During the issuance of Amendment No. 42, dated July 6, 1979, to Provisional Operating License No. DPR-13 for the San Onofre Nuclear Generating Station Unit 1, we inadvertently changed the Appendix B Technical Specification (ETS) 5.3.2.a, membership of the Nuclear Audit and Review Committee (page 5-5), instead of ETS 5.3.1.a, membership of the Onsite Review Committee (page 5-1). In addition, Figures 6.2.1.1 and 5.2-1, which were approved by Amendment No. 42, were unintentionally omitted. The enclosed pages correct these editorial and administrative errors.

ATTACHMENT TO LICENSE AMENDMENT NO. 42

PROVISIONAL OPERATING LICENSE NO. DPR-13

DOCKET NO. 50-206

FIGURE 6.2.1.1
OFFSITE ORGANIZATION

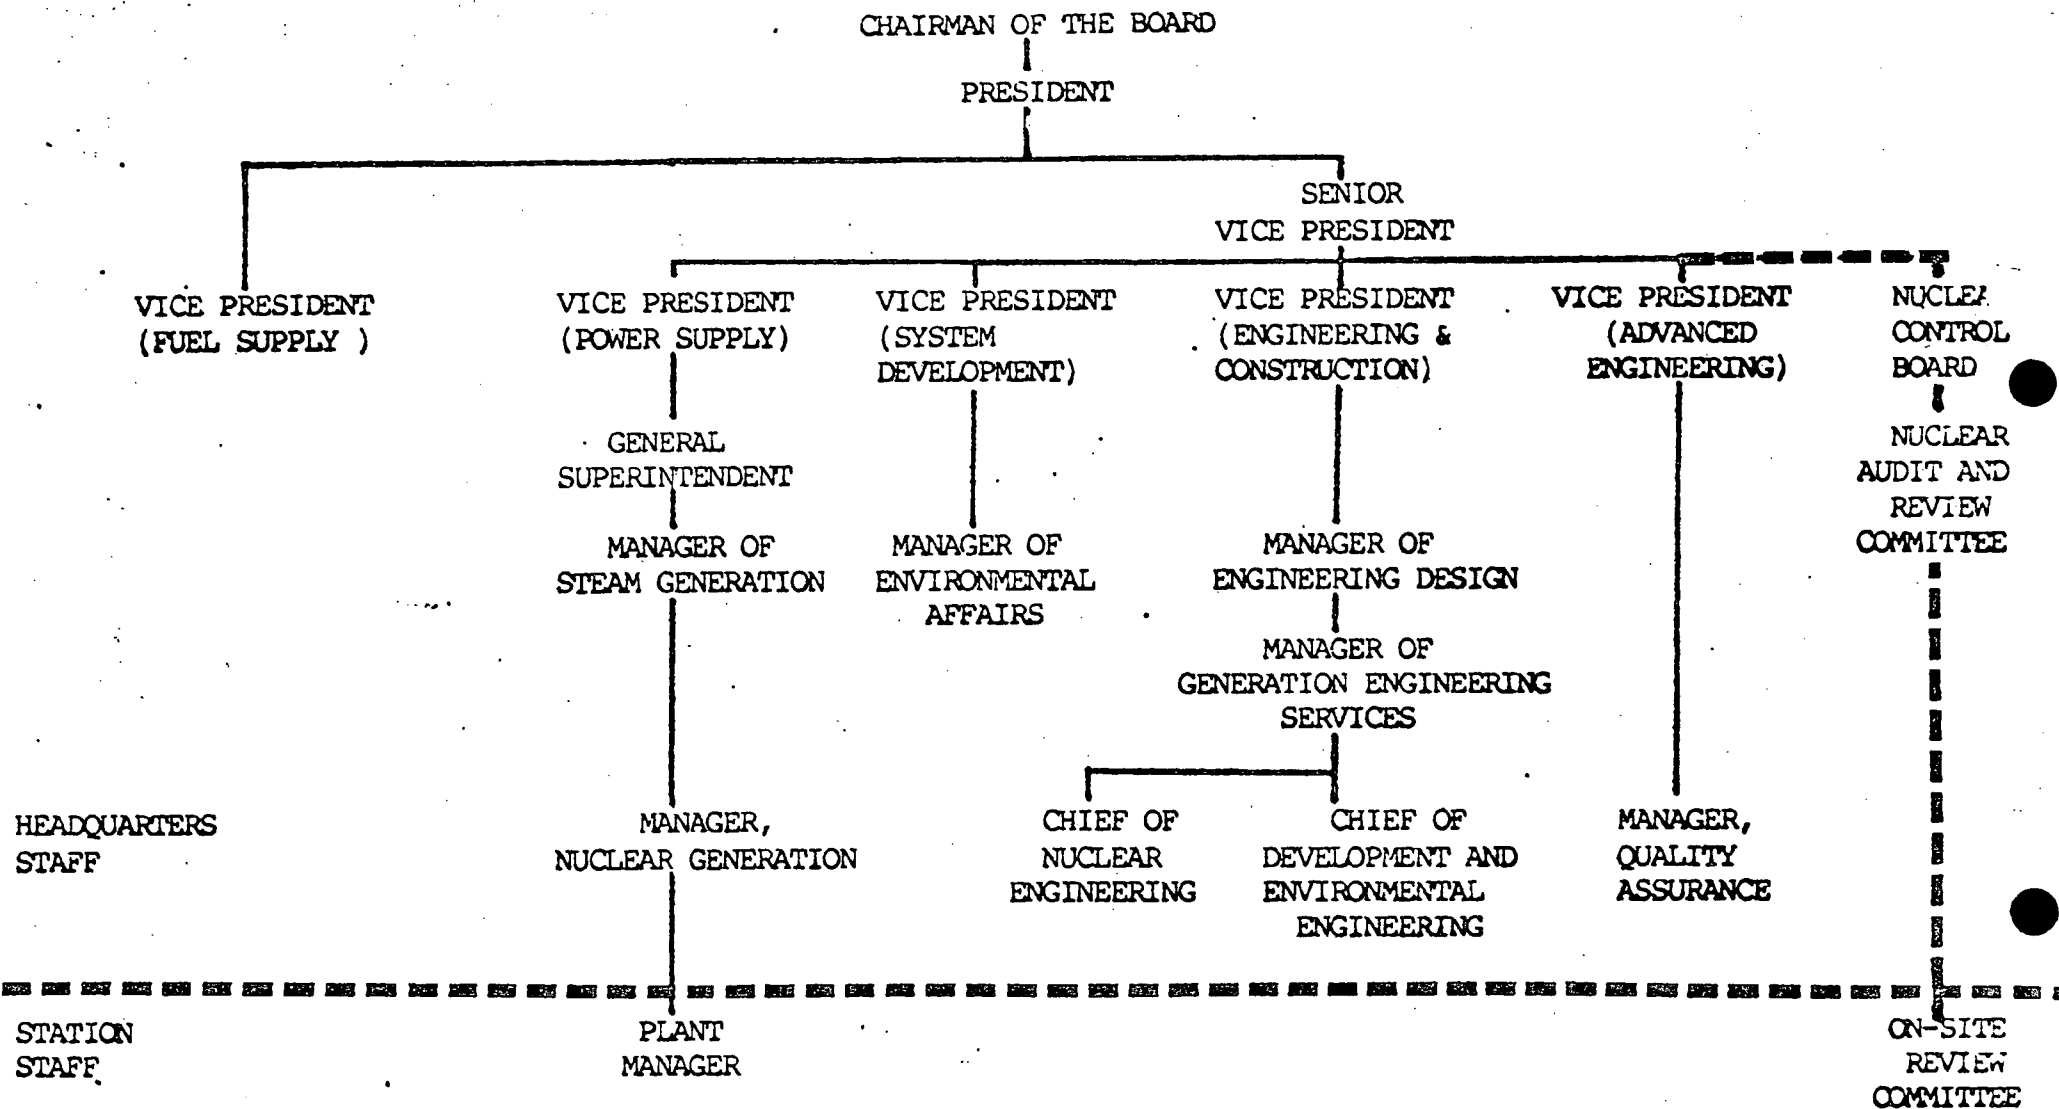
(Correction)

FIGURE 5.2-1 SOUTHERN CALIFORNIA EDISON COMPANY CORPORATE ORGANIZATION

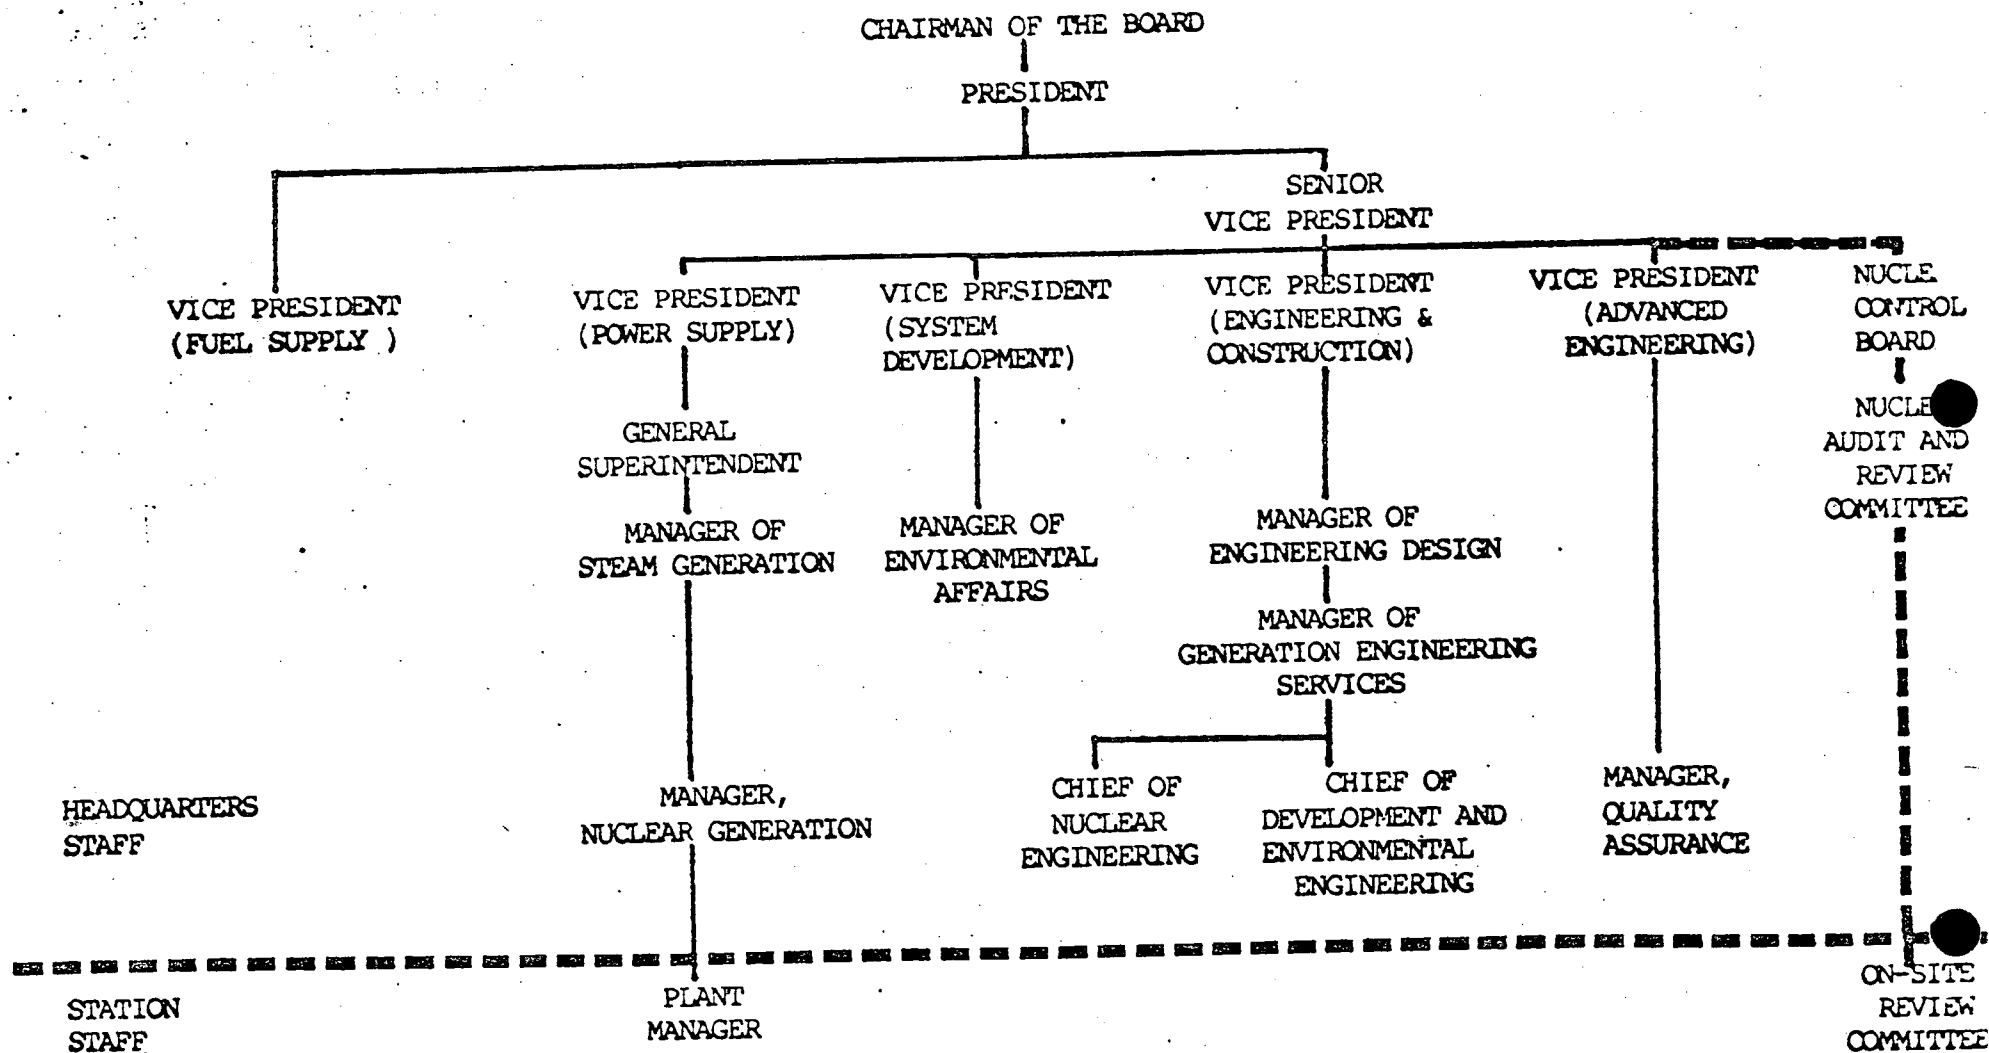
(Correction)
